Planning and Land Use Department Planning Commission Staff Report

<p>Case No: 2024-7998 (Preliminary Subdivision Plat)</p> <p>Hearing Date: January 16, 2025</p> <p>Applicant: Homewise, Inc.</p> <p>Agent: JenkinsGavin, Inc.</p> <p>Request: Preliminary Subdivision Plat</p> <p>Location: 3730 South Meadows Road</p> <p>Case Mgr.: Janice Biletnikoff, AICP</p> <p>Zoning: R-6 (Residential, six dwelling units per acre) Suburban Archaeological</p> <p>Overlay: Review District and River & Trails Review District</p> <p>Pre-application</p> <p>Mtg.: May 25, 2023</p> <p>ENN Mtg.: February 21, 2024</p>	
<p>Proposal: Preliminary Plat approval for a 97-unit 14.41-acre residential subdivision and 5.12-acre park development.</p>

Case 2024-7998. Los Prados Preliminary Plat. JenkinsGavin, Inc., Agent, for HomeWise, Inc., owner and applicant (“Applicant”), requests review and approval of a Preliminary Subdivision Plat, per § 14-3.7(B)(3) of the Land Development Code, for a 97-unit residential development consisting of 42 townhomes and 55 single-family detached homes, as well as the development of a 5.12-acre public park. The subject 14.41-acre parcel is located at 3730 South Meadows Road and is zoned R-

Figure 4: Lot Line Adjustment and Enlarged View of New/Old Lot Lines

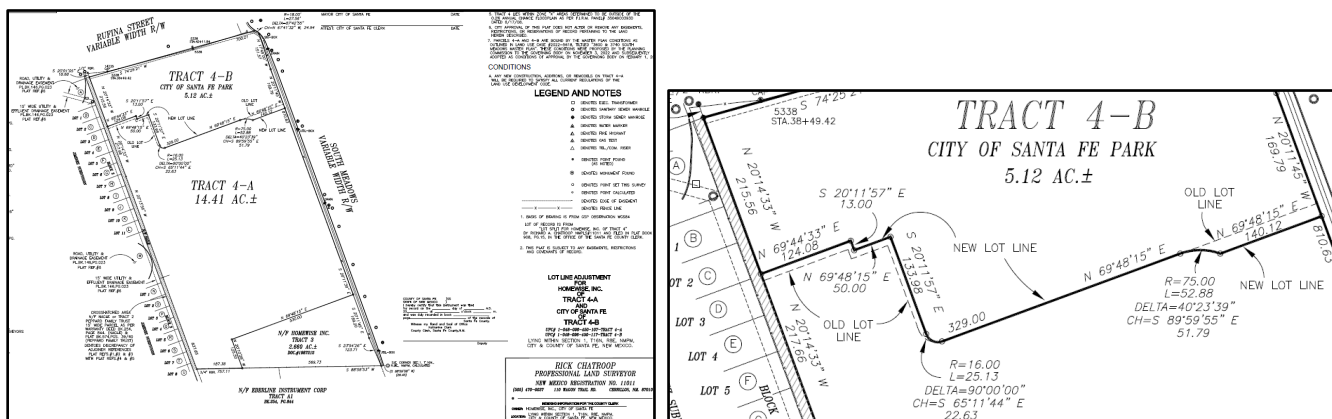
The preliminary plat depicted in the Application is based on a pending administrative lot line adjustment (“LLA”) on the Property. The Applicant applied for an LLA for the property line between Tract 4-A and Tract 4-B. This application was assigned case #2024-8764. The Applicant requested the LLA in order to correct an error in the boundary between the Park and residential subdivision on the recently recorded plat (see Figure 2, above). The error was the result of an internal oversight by the Applicant’s contractor. Following the initial submittal of the Preliminary Subdivision Plat application, the Applicant noticed that an earlier version of the Park boundary had inadvertently been included in the parcel layout. The constructability of the intended lot configuration would be impacted if the erroneous boundary line remained. The LLA proposal includes a slight modification to the southwest corner of Tract 4-B and southeast corner of the Park parcel, with an even exchange of land (2,727 SF) between the two parcels. See Figure 4, below, for a detailed depiction of the lot line adjustment. The Applicant is currently making the required revisions to the LLA plat in order to finalize and record the new Property lines. The Preliminary Subdivision Plat request is based on the lot lines as intended.

33.	The Applicant shall receive final approval of the Lot Line Adjustment (LLA) (case # 2024-8764) and have recorded the final LLA plat.	Land Use	Prior to Final Plat hearing
34.	The Applicant shall demonstrate compliance with each of the conditions of approval, technical corrections and notes as found in Attachment B: <i>"City DRT Conditions of Approval, Technical Corrections, and Comments."</i>	Various departments	Various

Figure 8a: Subdivision Access Off South Meadows Drive

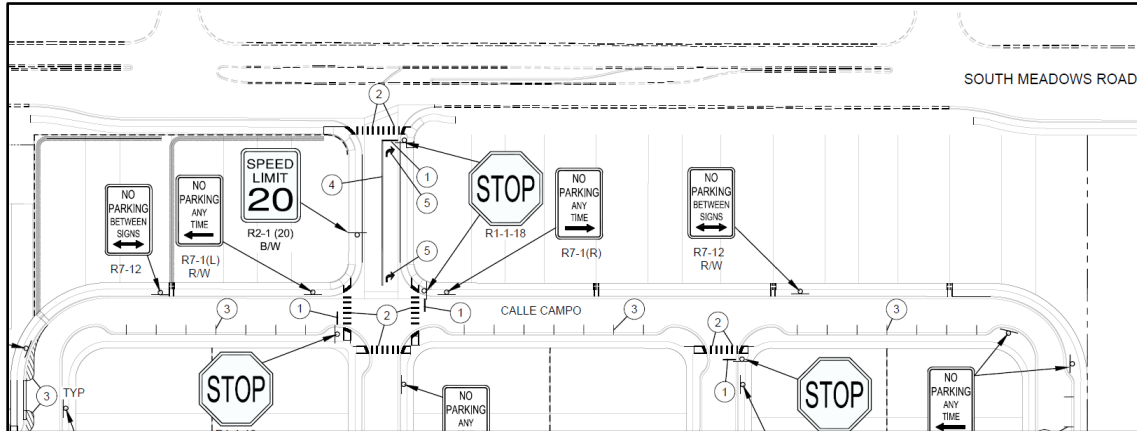
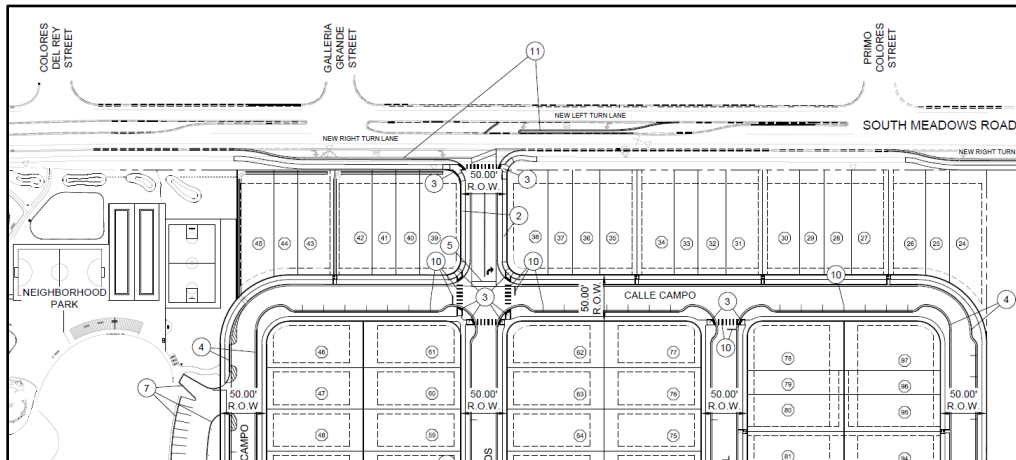
The Application also proposes two speed-change lanes along South Meadows Road, turning southwest into the subdivision: a left deceleration lane and a right deceleration lane. The Applicant’s engineer stated that the anticipated volume of traffic warranted the right deceleration lane, based on Table 17.B-1 of the State Access Management Manual (SAMM) which is written and implemented by the State of New Mexico Department of Transportation; however, the City did not agree with this assessment. The City’s DRT members (Public Works Department, Traffic Engineering and the MPO) worked with the Applicant and their engineer regarding this proposal, and it was ultimately decided that the deceleration lane must be removed from the plans. In assessing traffic and road safety, the City does not utilize NMDOT’s SAMM but rather is transitioning to the new *Transportation Impact Analysis Guidelines* (TIA Guidelines) which are currently pending adoption and are better

tailored to City streets than highways. When the anticipated levels of traffic for the Los Prados subdivision are assessed using the new *TIA Guidelines*, the projected number of right-turning vehicles did not meet the minimum vehicular threshold for requiring a deceleration lane. It was also noted that the inclusion of unwarranted turn lanes creates a less-safe situation for the more vulnerable users of the roadway, such as bicyclists and pedestrians. The decision not to add two additional lanes to the overall road width keeps South Meadows Road narrower, which contributes to overall traffic calming and enhances safety for all roadway users.

7.	Pedestrian scale sidewalk lighting (solar lighting options preferred) shall be provided.		Prior to Building Permit
8.	Remove the right turn (deceleration) lane into the Los Prados subdivision from South Meadows Road.		Prior to Final Plat hearing

Figure 11: Fire Hydrants

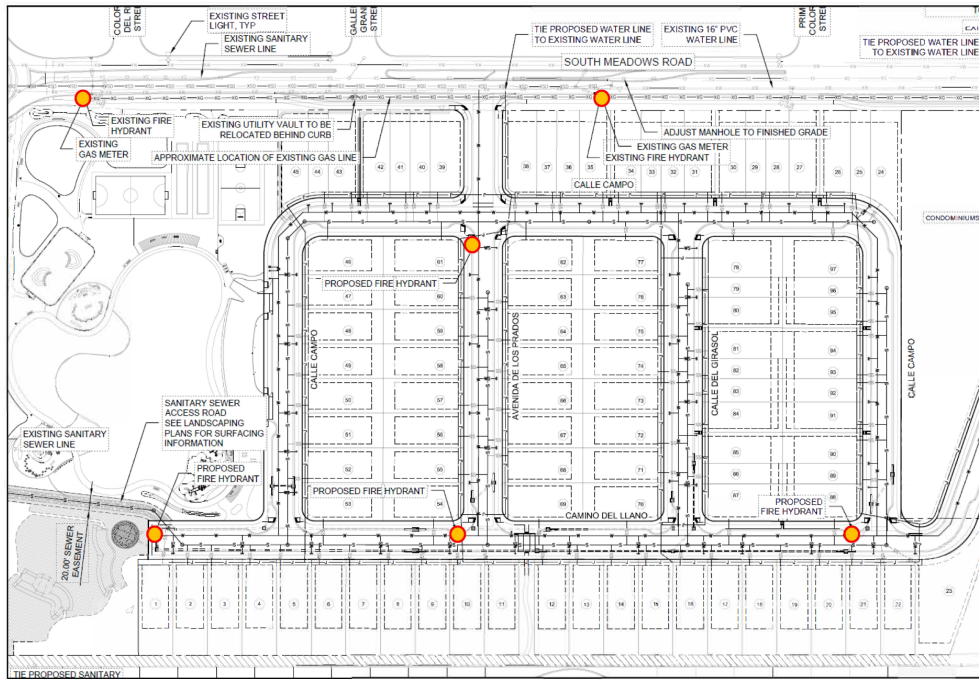
The Fire Marshal has required an unobstructed width of no less than 20', exclusive of shoulders, for driving lanes throughout the subdivision, which the Applicant has provided. The Applicant proposes four new fire hydrants: three along Camino Del Llano and one along Avenida De Los Prados (see Figure 11, below). The Fire Division provided technical corrections to be implemented at the time of development (see Attachment A "Development Review Comments" and Attachment B "Technical Corrections."

10.	IFC: 503.2.1 Fire apparatus access shall have an unobstructed width of not less than 20 feet exclusive of shoulders and an unobstructed vertical clearance of not less than 13 feet 6 inches (this would also include anticipated on street parking, unobstructed parking is crucial to community life safety response.)	Fire Protection District	Prior to Final Plat hearing as a note on the plat

11.	IFC: 503.4 Obstruction of Fire Apparatus Access Roads. Fire apparatus access roads shall not be obstructed in any manner, including the parking of vehicles. The minimum widths and clearances established in Section 503.2.1 and 503.2.2 shall be maintained at all times and this requirement shall be noted as such on the Final Plat.		Prior to Final Plat hearing as a note on the plat

Figure 14: Raingarden/Stormwater Detention Area (NW corner of Park parcel)

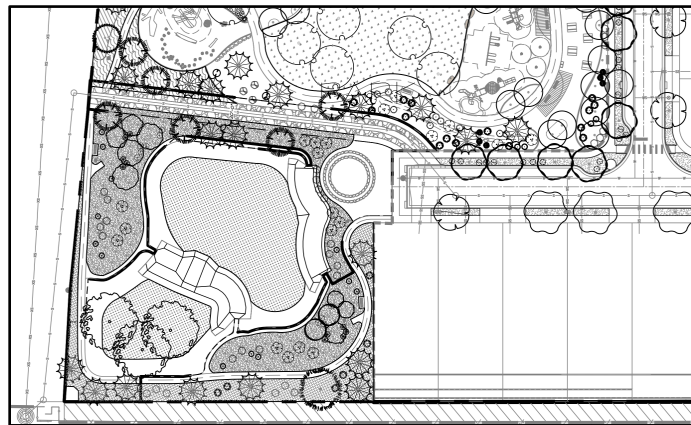
Due to the presence of an existing natural depression in the northwest area of the Park parcel, the Applicant has proposed a raingarden in this location as a passive stormwater harvesting and detention site (see Figure 14, below). This ponding area is located within the City Park property but will collect and percolate inputs from both the Park and the adjacent Los Prados subdivision. Stormwater conveyance facilities from throughout the subdivision will collect runoff and these facilities will extend into the Park for deposit into the raingarden. The Los Prados Homeowners' Association will be responsible for the ongoing maintenance of these facilities through an easement with the City. Per the Master Plan, the maintenance of such improvements will be conducted in accordance with the City's adopted drainage maintenance requirements and schedule. The City's Land Use Engineer has reviewed the Application materials and submitted technical corrections as redlines on the plans, as well as comments and conditions of approval (see Attachment B: "City DRT Conditions of Approval, Technical Corrections, and Comments").

32.	The Applicant shall obtain final design approval for the raingarden/stormwater detention facility from the Land Use Engineer.		Prior to Final Plat hearing
